Griffith UNIVERSITY
Planning, Design & Construction, Campus Life

Pending Amendments to Clauses in the Griffith University Design Guidelines & Procedures Version 18

Edition 18.1

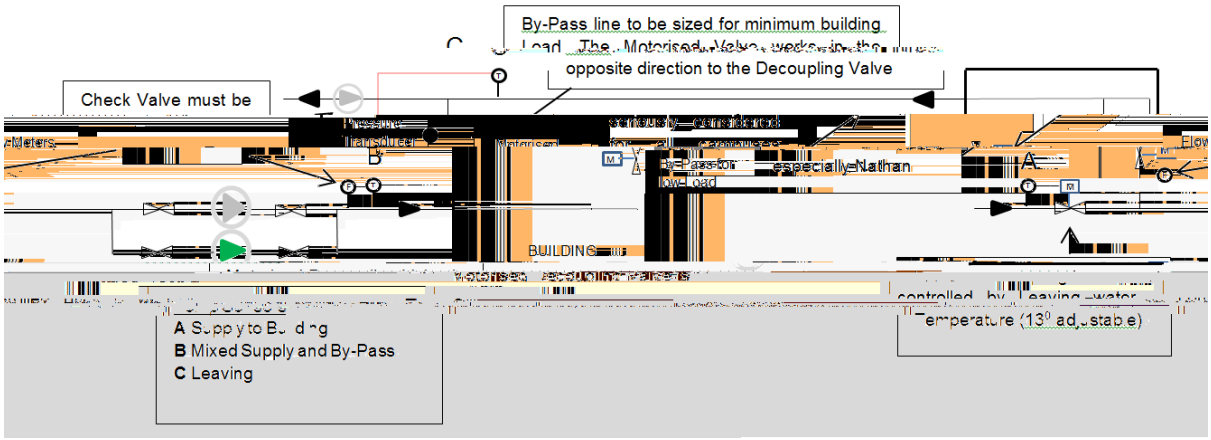
The VSD of any secondary chilled water pump shall be controlled by a pressure transducer located in an easily accessible location at approximately two thirds (2/3) of the distance along the index chilled water pipe run. The pressure transducer pipework shall be configured as shown in the following Diagram 18.ii.

Secondary Chilled Water Pipework Layout – The supply and return pipework within a building, shall incorporate the secondary pipework and control/monitoring valves and equipment as shown on the following Diagram 18.iii
